Applicable Urban Design Priorities Project Should Achieve

Gateway Oak Cliff is a four-story mixed-income multifamily development proposed on a 3.1 acre site at the intersection of Beckley Avenue and East Twelfth Street in North Oak Cliff. The site is currently occupied by a Dallas County Tax Office and will be redeveloped through a variety of funding sources, including Low-Income Housing Tax Credits (LIHTC). The project will contain approximately 230 units, with roughly 75% of the units being dedicated for residents making 80% or less of Area Median Income (AMI).

Gateway Oak Cliff

FIRST FLOOR PLAN

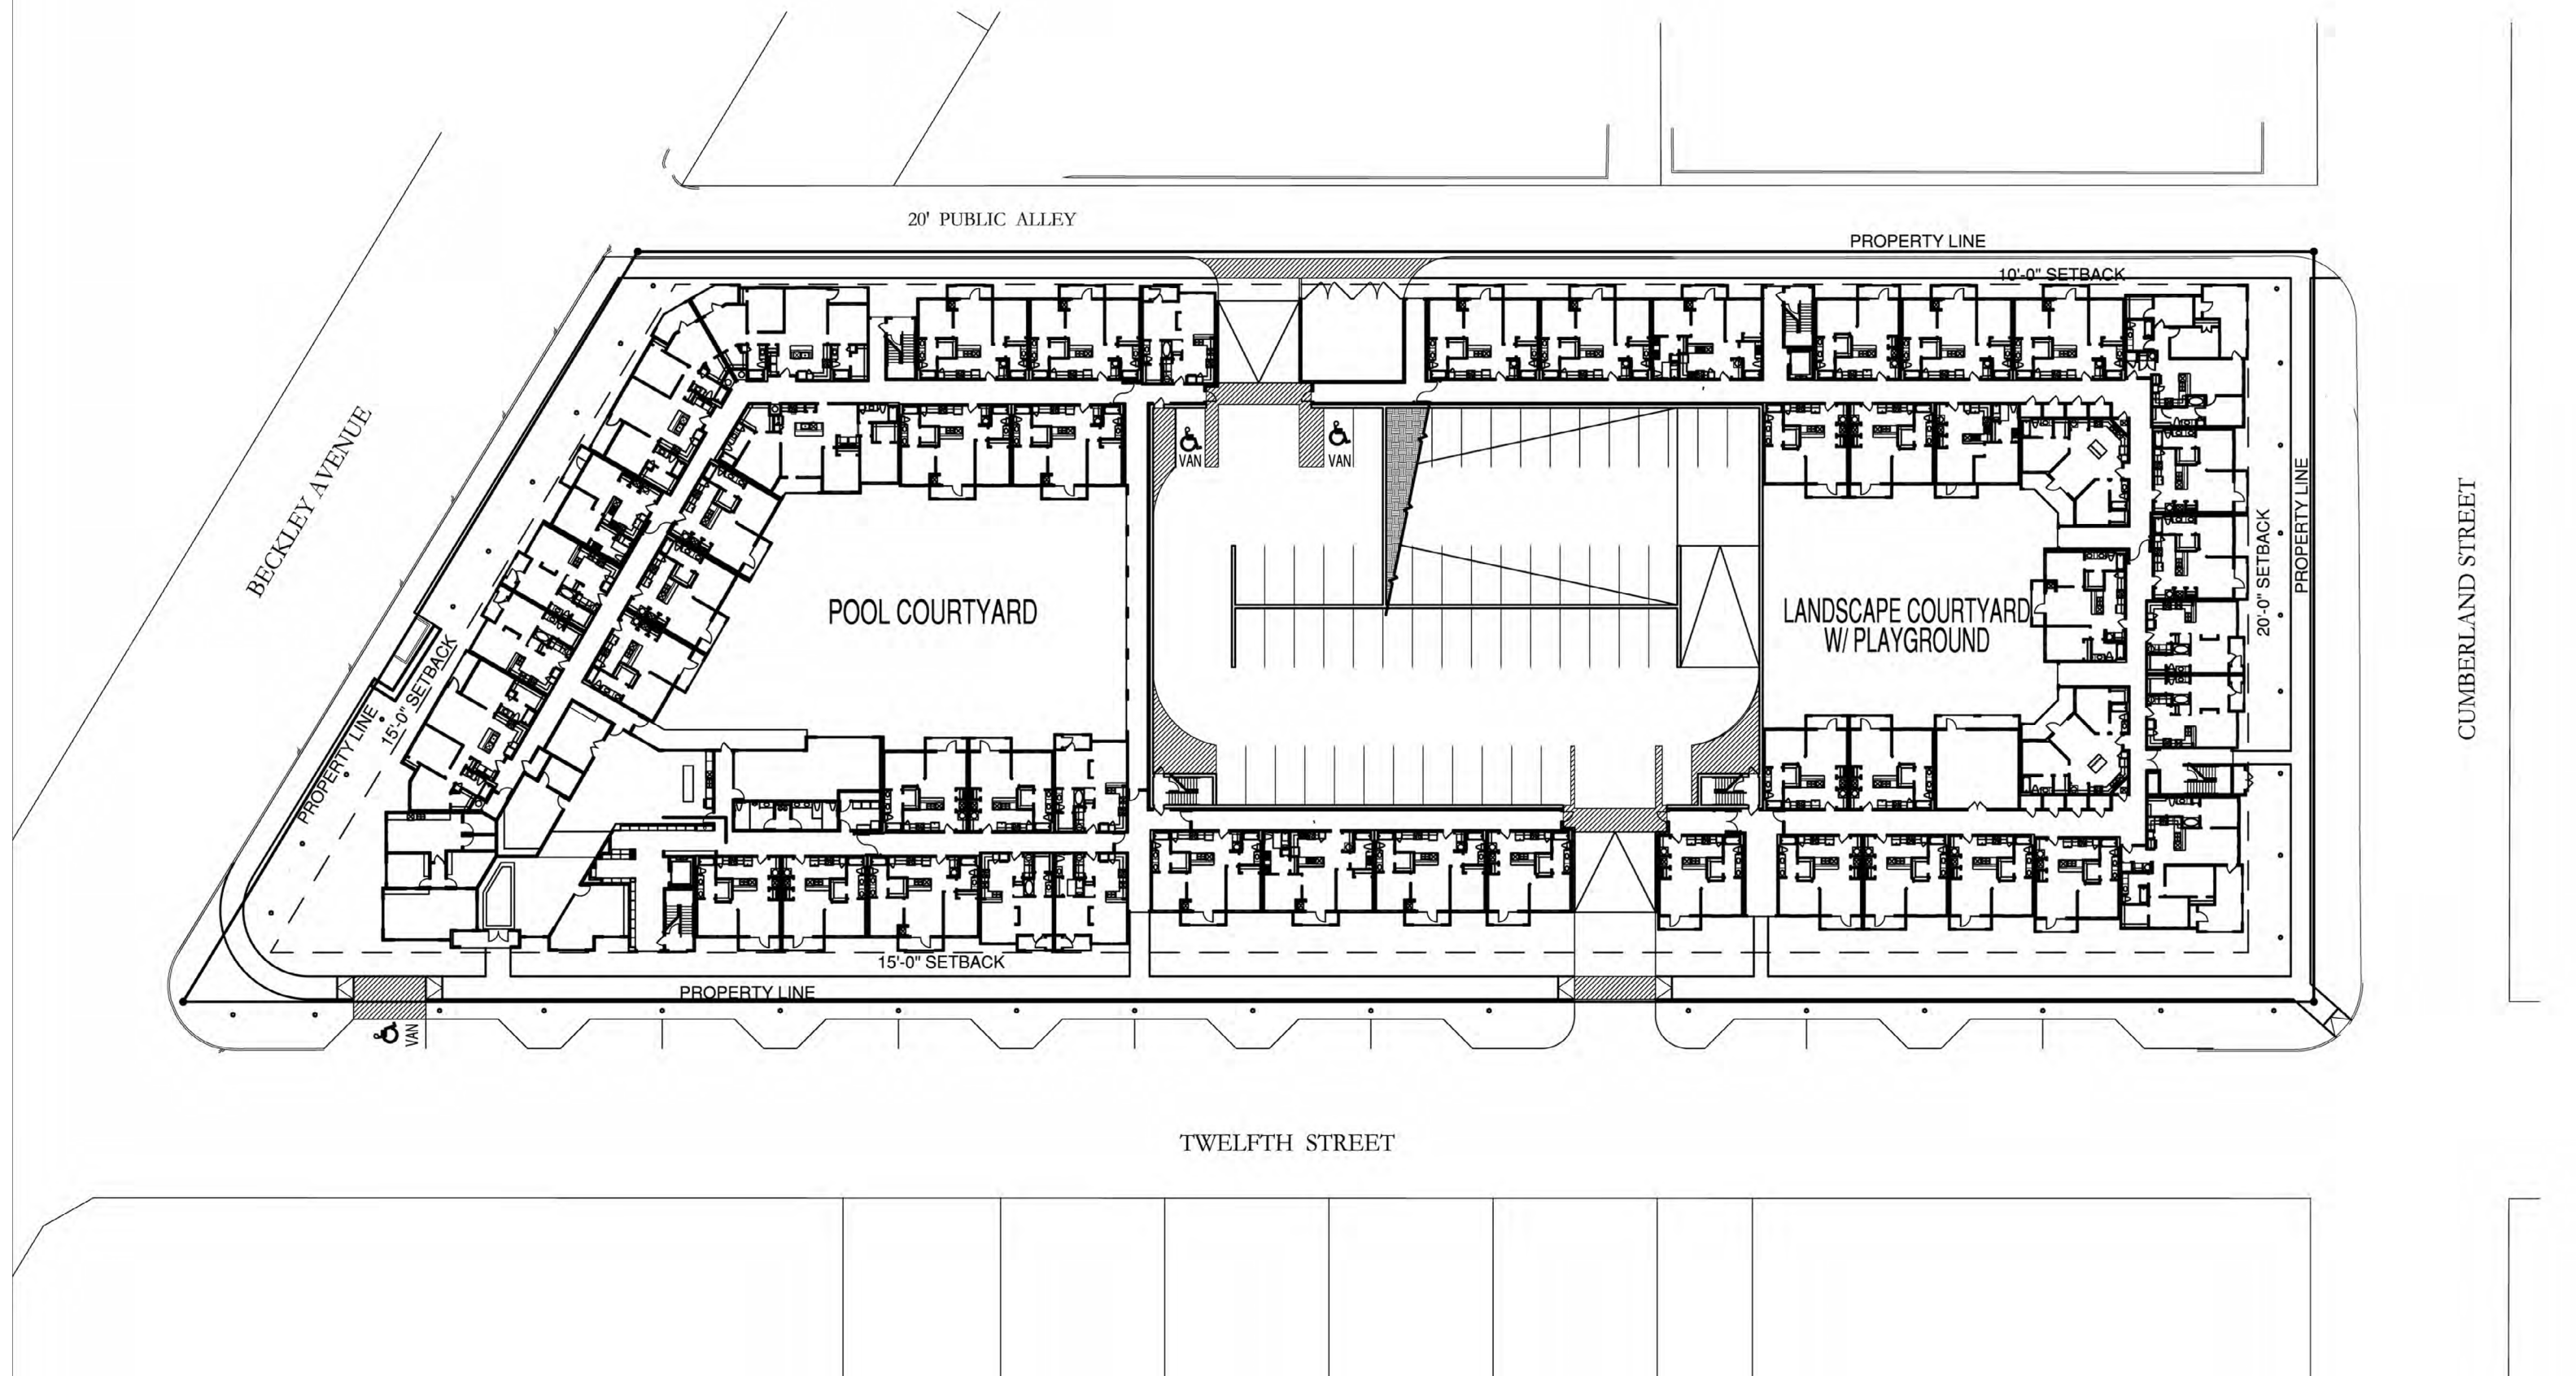
- [1] Enhance the pedestrian experience along all frontages of the project through streetscape design, with particular focus being given to the public realm along Beckley and East 12th.

Attention should be given to an inviting streetscape providing a variety of elements that enhance pedestrian comfort, interest and safety, including wide sidewalks, street trees, a layered landscape buffer between the back-of-curb and the sidewalk, and other pedestrian amenities such as pedestrian lighting, seating and bike racks. Additional focus should be given to moments where the streetscape crosses proposed driveway cuts and at the prominent corner at Beckley and East 12th.
- [2] Explore opportunities for ground floor residential units to provide direct entries from the public realm.

The development team should explore ways in which to provide safe and protected ground-level units to activate the public realm and provide eyes on the street by allowing for direct access from the street through usable and gated patios.
- [3] Consider redesigning the proposed angled parking along East 12th Street as parallel parking.

Parallel parking will help calm traffic, provide space for curbsude drop-off/pick-up, and will create less dangerous movements for cars and pedestrians.

Primary considerations for this project include the design of the streetscape around all side of the project, particularly along Beckley and Twelfth Street. Additional considerations include the design of the proposed parking along East Twelfth and the recommendation to provide ground-level entries to as many ground-level units as possible.
